TECHNICAL NOTE

PROJECT: Land west of Pagham Road – Approval of Reserved Matters (planning references: P/155/21/RES and P/158/21/RES)

REPORT: 2152/TN/03 – Response to highway officer consultation dated 30th November 2021

NOTES:

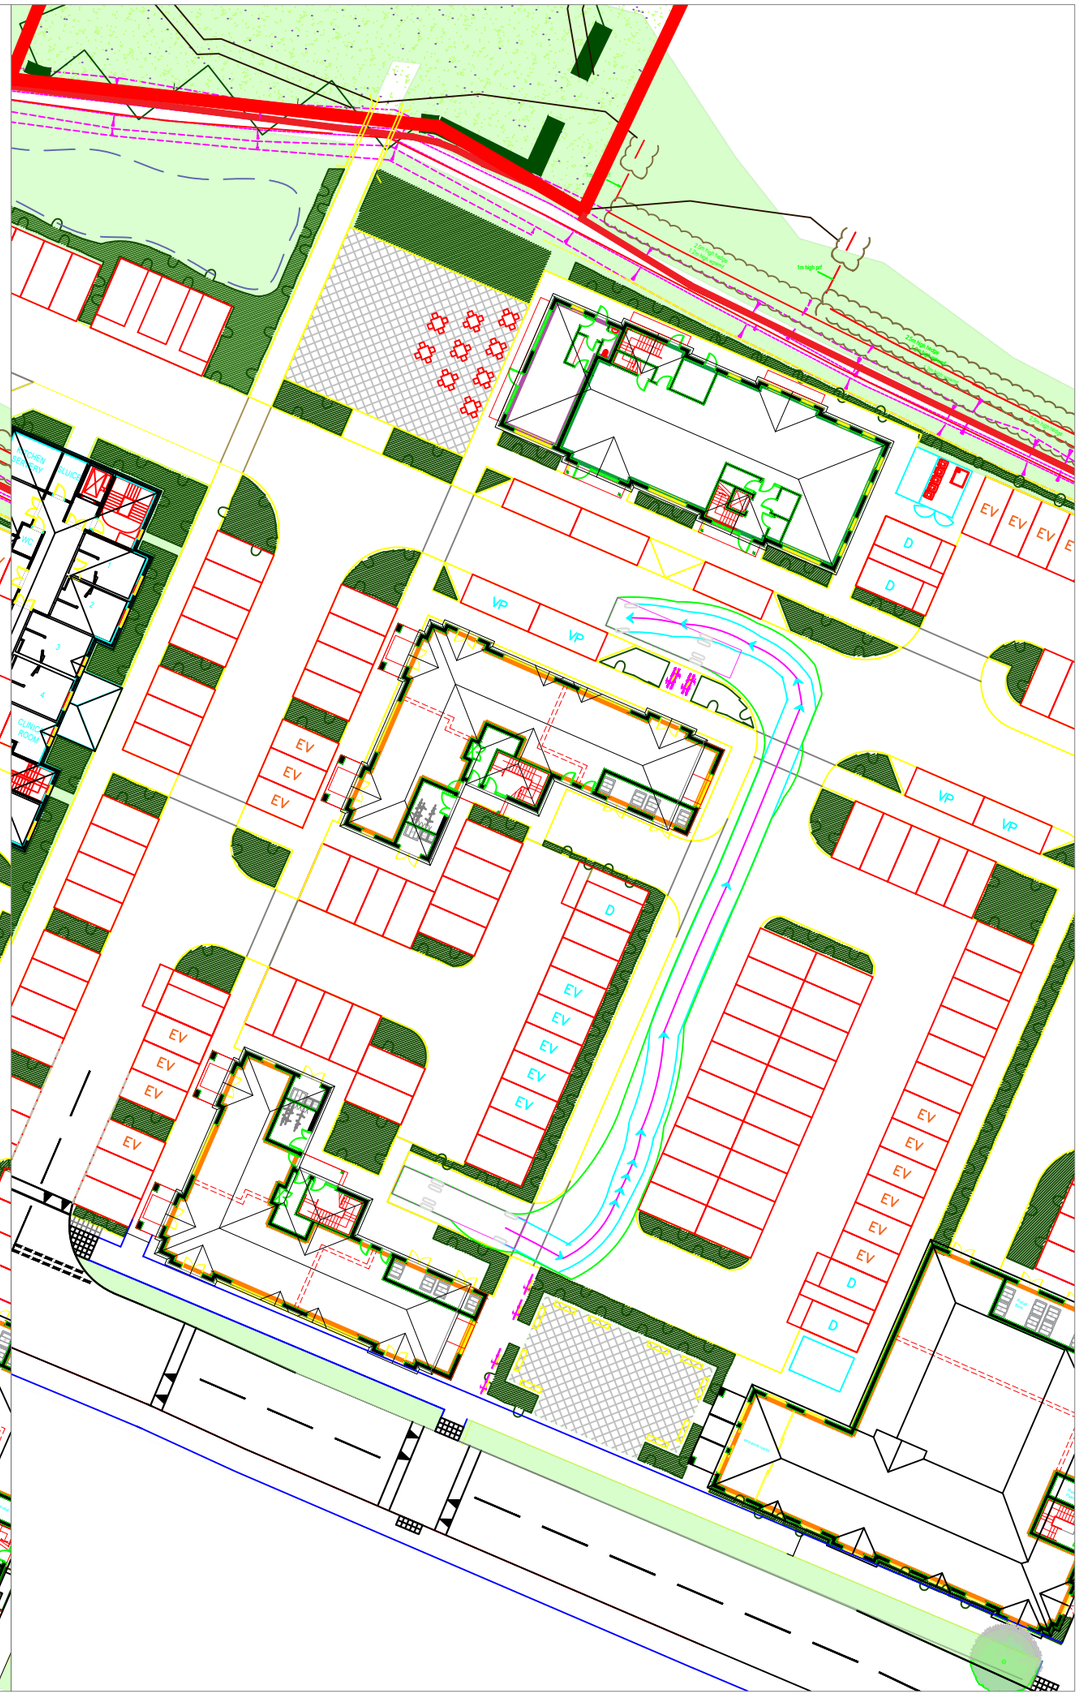
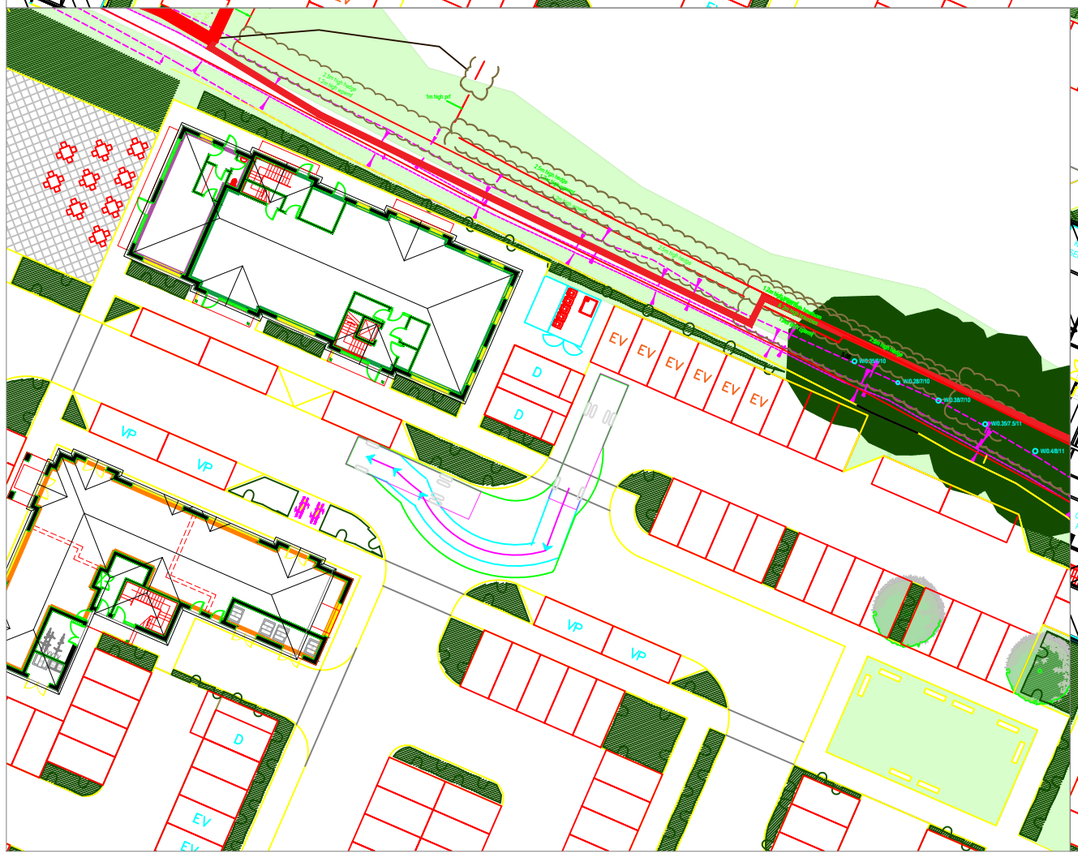
Along the frontage of the local centre and school the spine road is shown with a width of 7.3 metres, further justification of this width should be provided to show that it is compatible with the 20mph speed restriction proposed

In terms of more detailed matters, WSCC Highways have previously questioned the need for the 7.3 metre wide road across the school frontage; this road width is considered at odds with the 20mph design speed proposed. This aside, very limited consideration appears to have been given particularly to the potential demands arising from the school site (i.e. parent parking, dwell space/footway widths along the frontage) or the need for school safety zone type features (e.g. enforceable restrictions (i.e. 'School Keep Clear and No Waiting At Any Time (which may need to be wrapped around onto Pagham Road also). The applicants for P/153/21 and the current application will need to incorporate such elements into the design.

11. Swept path analysis for an 11.0 metre refuse collection vehicle was provided within the Transport Statement that supports the application and is provided at **Appendix 2** for ease of reference. From this it can be seen that the road width is required to serve the local centre via the proposed access. It also likely that a similar road width would be required, in any event, for school buses/coaches (including those required for school trips).

12. The 7.3 metre road width is proposed to ensure that large vehicles are able to conveniently and safely serve the local centre and school sites. Speed tables form part of the spine road design to ensure compatibility with the 20mph speed restriction. The S278 approval for the spine road/Pagham Road junction confirms the spine road width to be 7.3 metres.

SPINE ROAD AND LOCAL CENTRE ACCESS

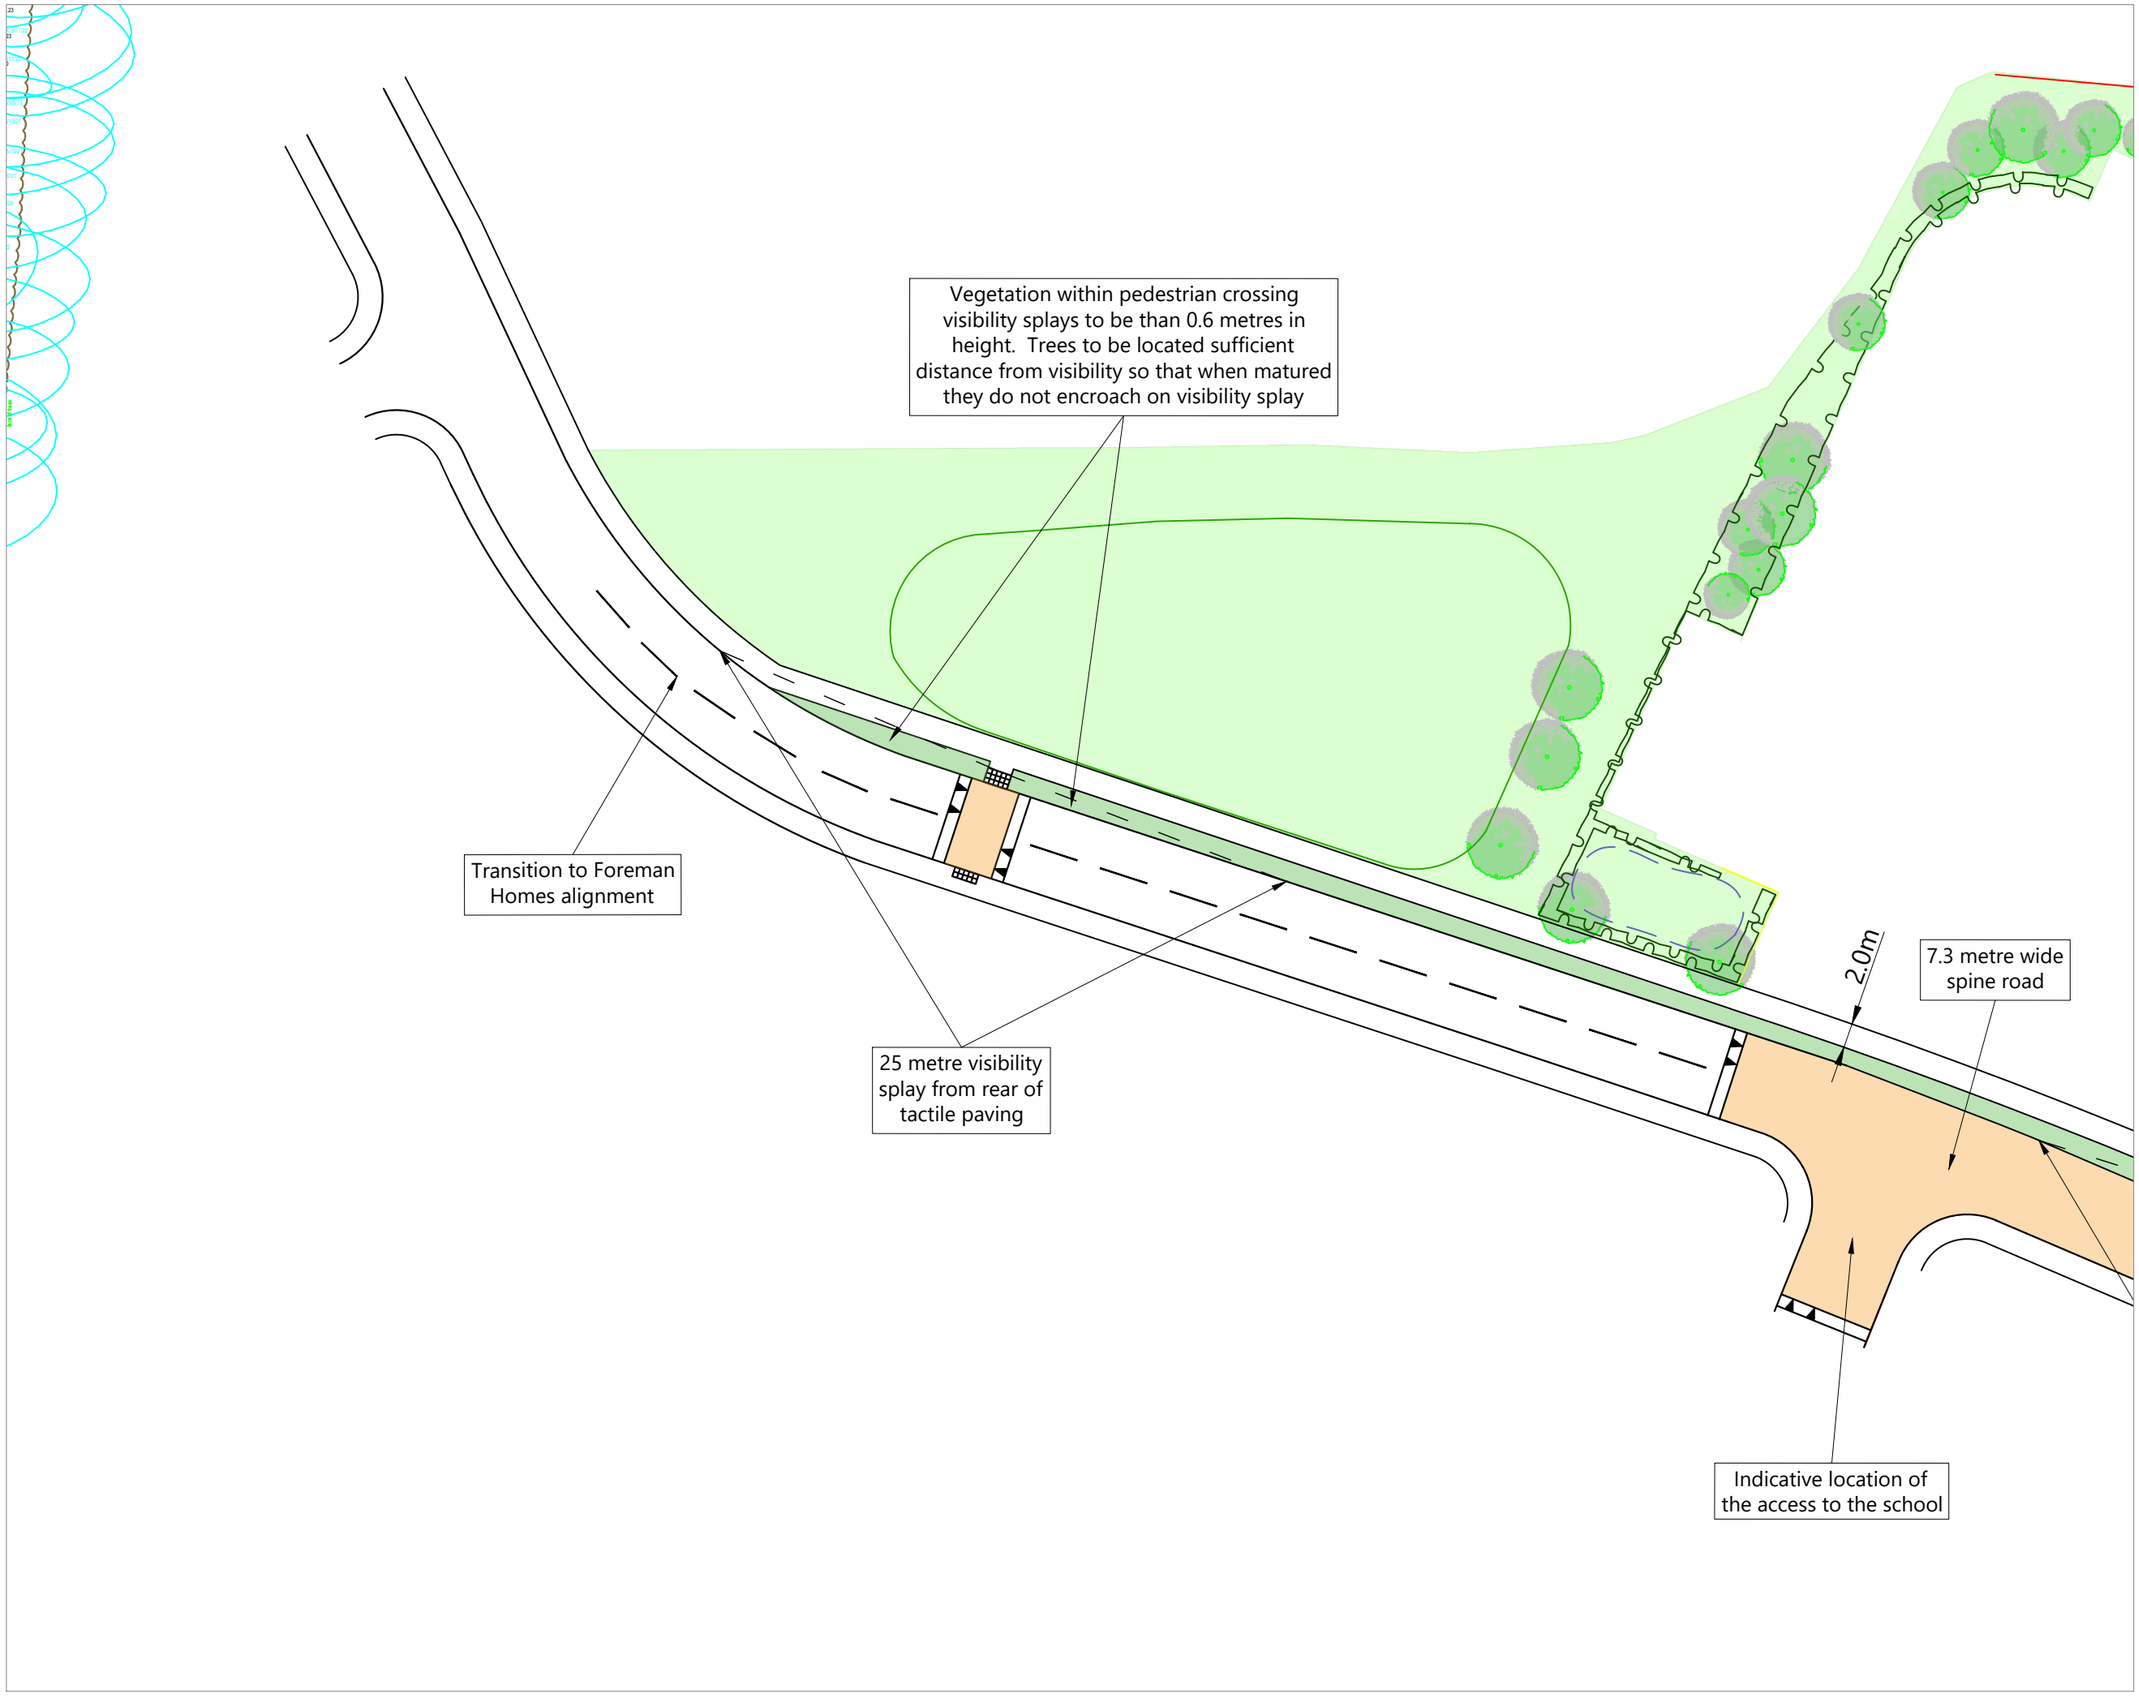
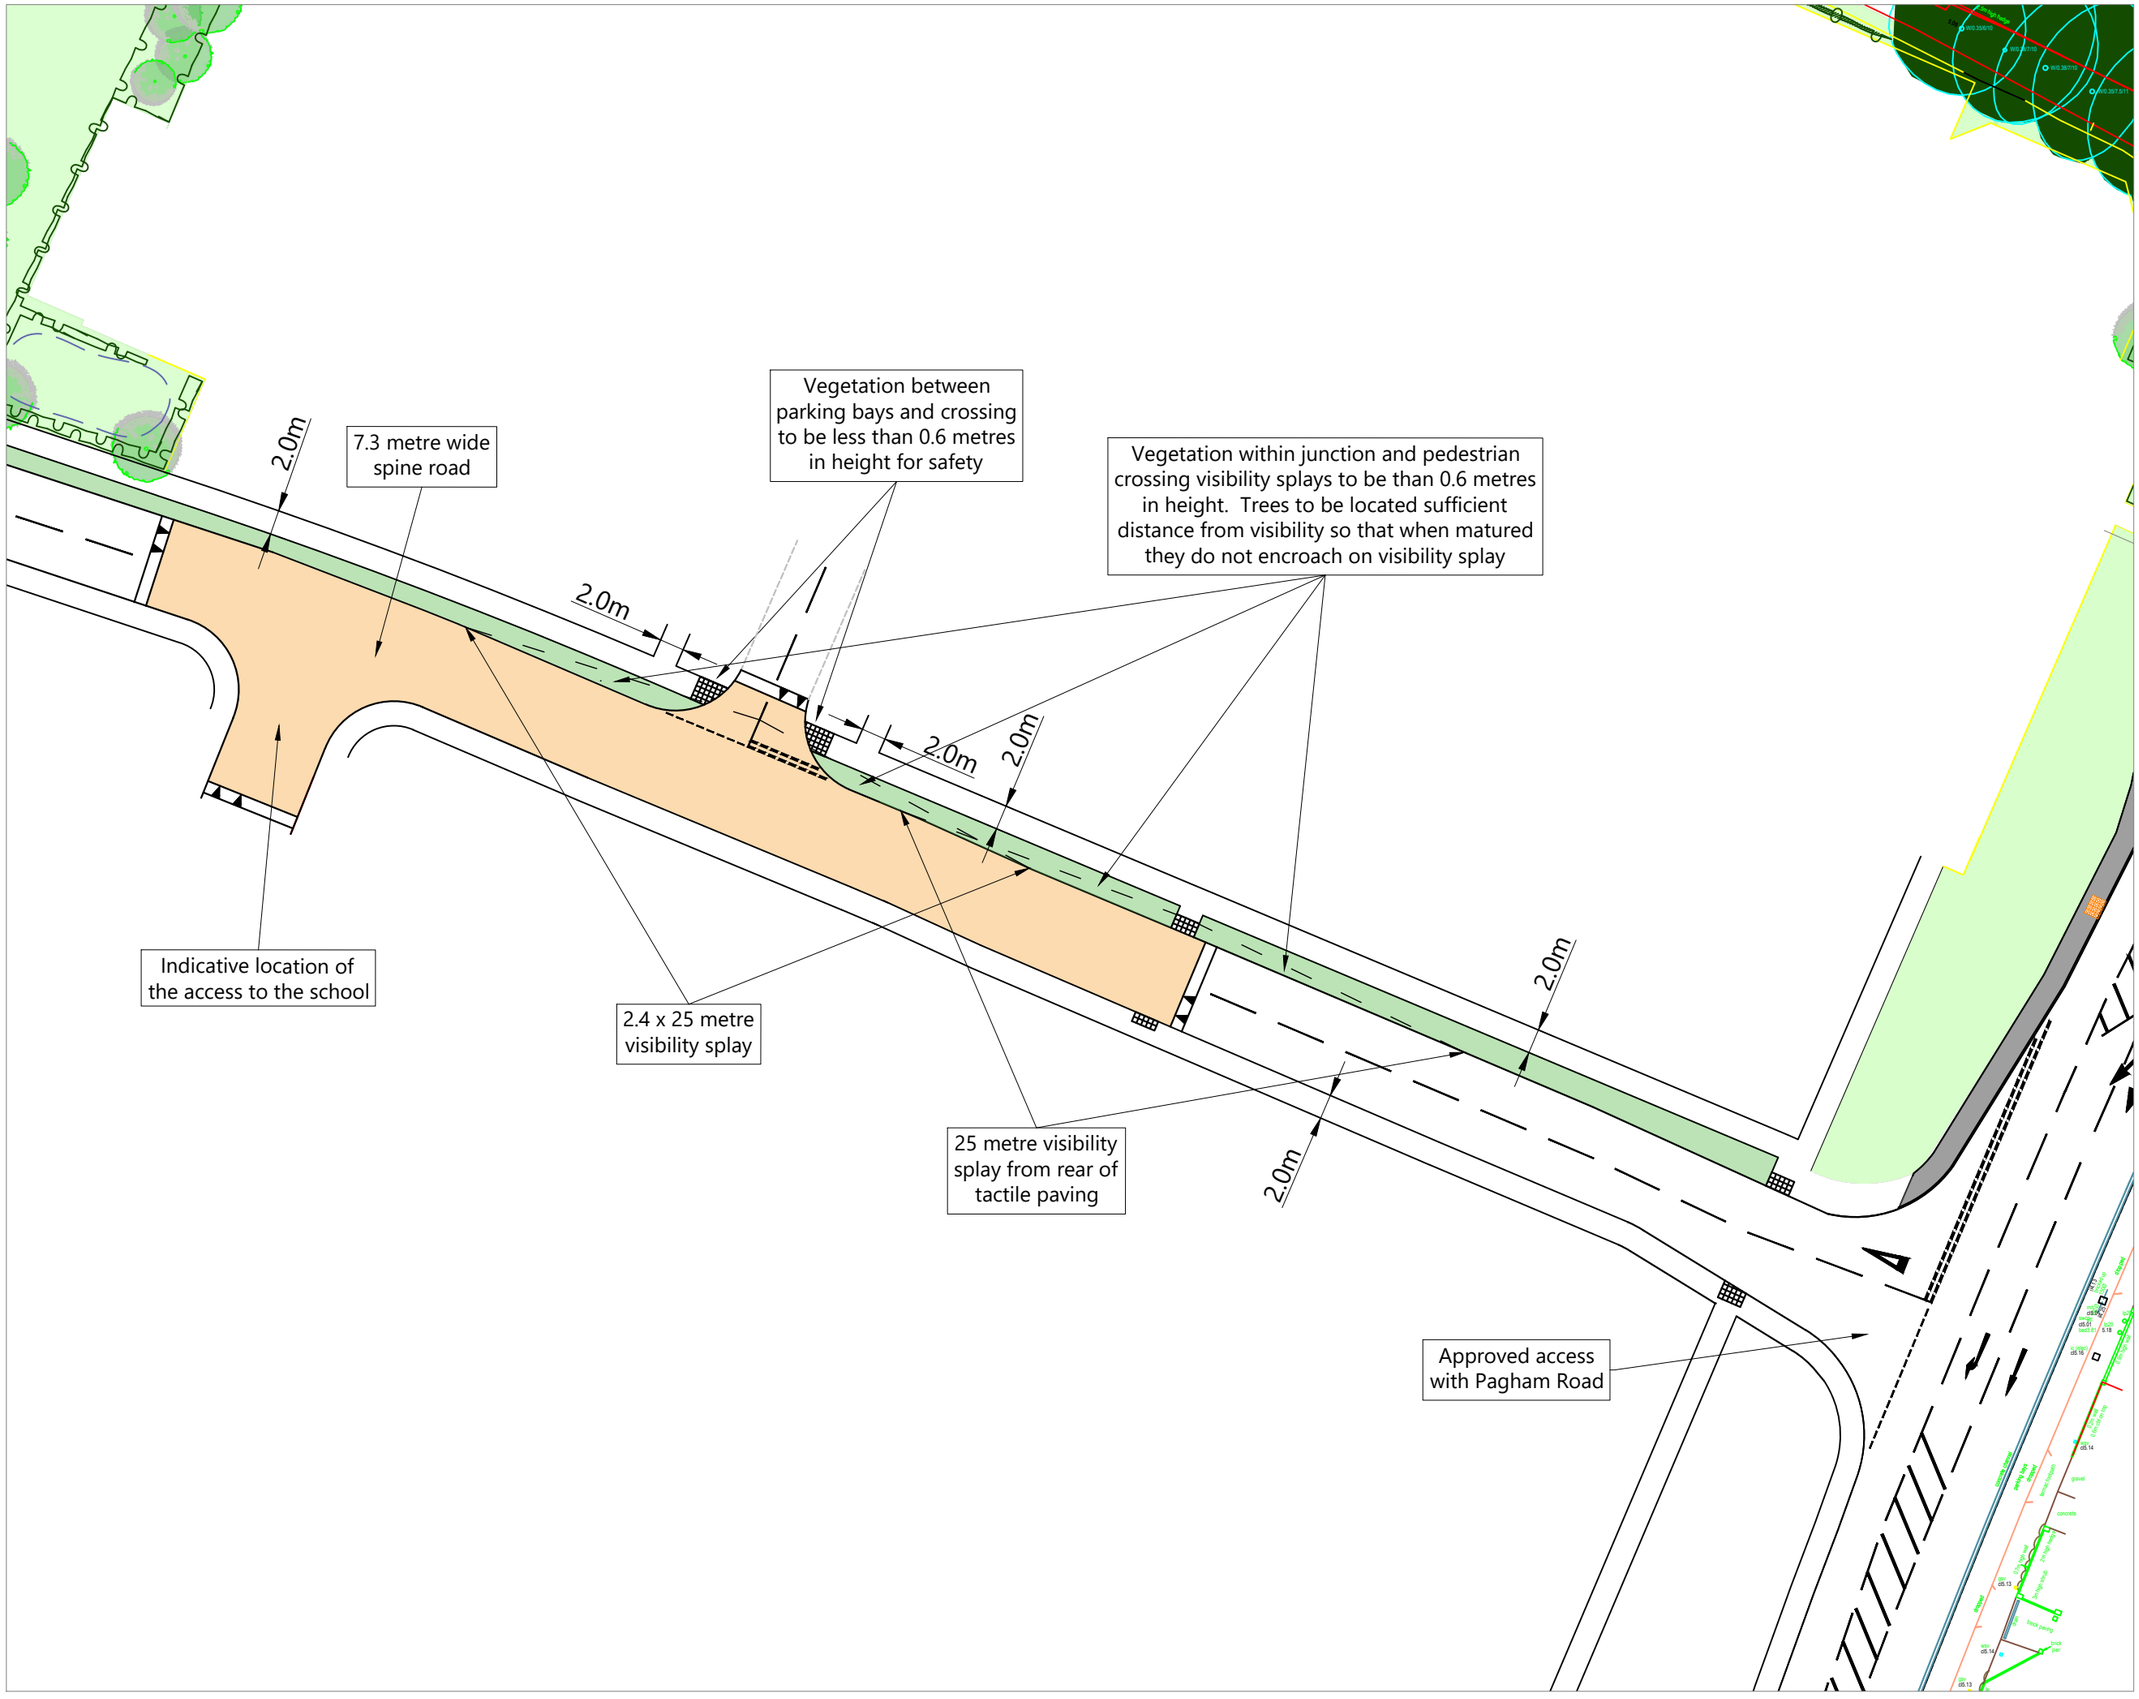
It's also recommended that the single raised feature to the west of the raised feature incorporating the community uses and school accesses are combined to form a single feature across the school/community use frontages. The single short raised feature in isolation serves little purpose particularly given it's close proximity the longer raised table.

16. A plan of the updated access proposals (HTp/2152/07/D) combining the main and eastern raised tables is provided at **Appendix 3** with an extract at **Figure 1**.

ISSUE	REASON FOR REVISION	BY	DATE
D	Raised tables modified	BL	14.12.21
C	Line colours modified	BL	29.10.21
B	Overview sheet added and pages renumbered	BL	28.10.21
A	Scale bar updated	BL	26.10.21
